Access Compliance Report

Public Rights-of-Way

(Curb Ramps)

Intersection ID: 28108	Main Street: BERITSTRASSE_CT	Cross Street: DARBY_CHASE_DR	Location: SW
ADA ID: F5969BDAEC1F	Ramp Type: Perp	Initial Pass/Fail: Pass	Overall Compliance: No
Severity Score: 30			
Codes/Mitigation Info/Possible Solution		Field Measurements/Component Compliance

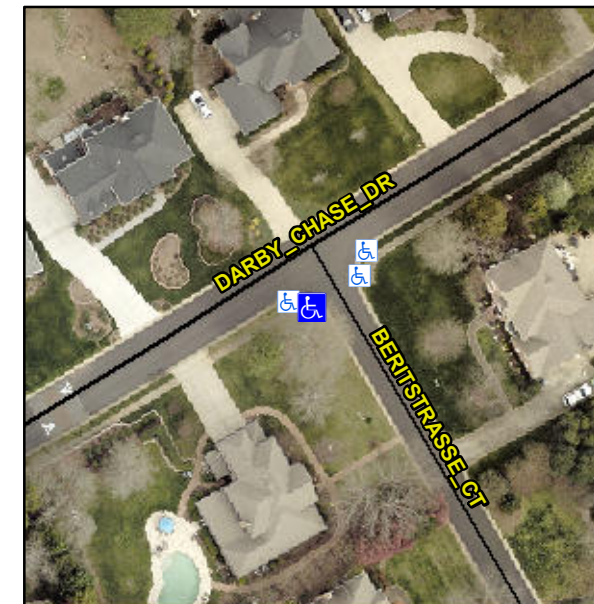
**R304.2.1, R304.2.2-Perp, R304.3.2-
Para, R305, R302.7.2, R304.5.4**

**Remove & Replace Entire Ramp.
Remove & Replace Gutter.**
